Pentium[®] Processor Specification Update

Release Date: June, 1997

Order Number 242480-028

2. **Incorrect TCP Pinout Drawing**

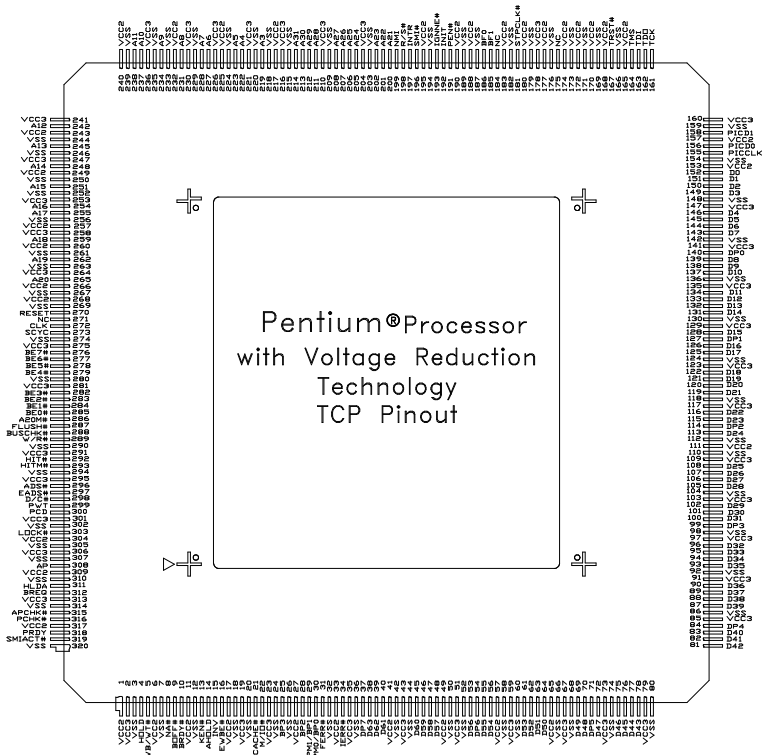
The TCP pinout drawing on page 8 of the *Pentium Processor with Voltage Reduction Technology* datasheet was inadvertently rotated. The correct orientation is shown below.

Figure 14-1. Maximum Undershoot Level, Undershoot Threshold Level, and Undershoot Threshold Duration

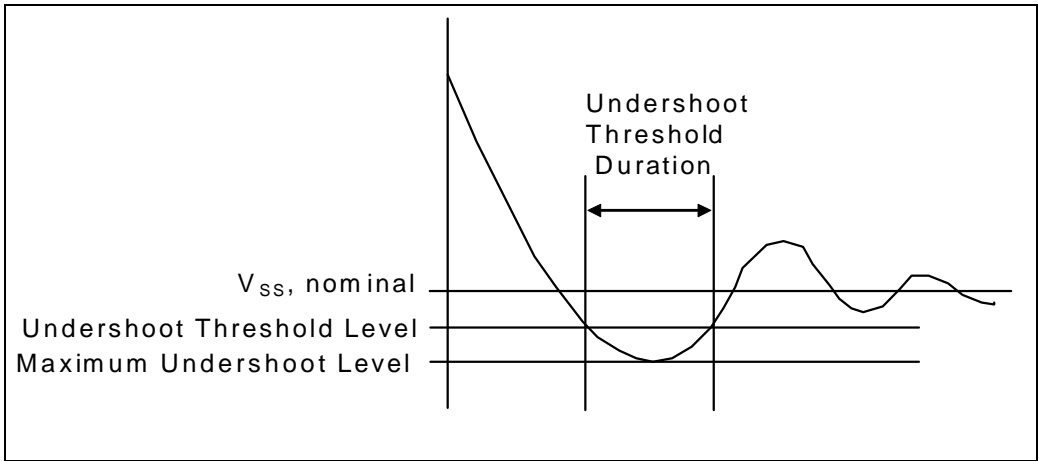
MAXIMUM RINGBACK SPECIFICATION: The maximum ringback of CLK associated with its low state (undershoot) must not exceed 0.8V as shown in Figure 14 -1.

UNDERSHOOT THRESHOLD DURATION SPECIFICATION: A snapshot of the clock signal should be taken at 500 mV/div and 500 pS/div (for CLK). Adjust the vertical position and horizontal offset position to view the threshold duration. The undershoot threshold duration is defined as the sum of all time during which the clock signal is below -0.5V within a single clock period. The undershoot threshold duration must not exceed 20% of the period.

This undershoot specifications are illustrated graphically in Figure 14-1 and Figure 14-2.
